POLICE TRAFFIC MANAGEMENT

I acknowledge and endorse the points raised by HCC and have the following additional observations: - (Points in italics are taken from TMP V.0a submitted by

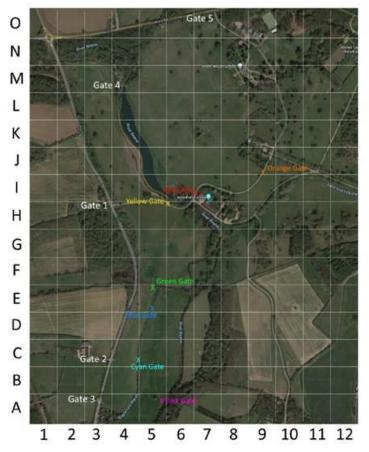
I note the vehicular access points (Gates 2 & 3) have been improved. I've not recently been to site but am interested to know if the organiser can confirm the site now provides not less than the minimum visibility splays in accordance with the Design Manual for Roads and Bridges?

The plan includes a map which shows Gates 1-5, plus seven additional gates identified by a colour (see below).

I note Gate 2 will be used for entry and Gate 3 will be used for exit. The TMP provides insufficient information to understand how the additional ten gates will be used.

Photographs of Gate 2 and Gate 3 on pages 5 and 6 of the TMP appear to be the same location rather than two different locations?

The TMP includes insufficient information to understand how and for what purpose gates other than 2 and 3 will be used.
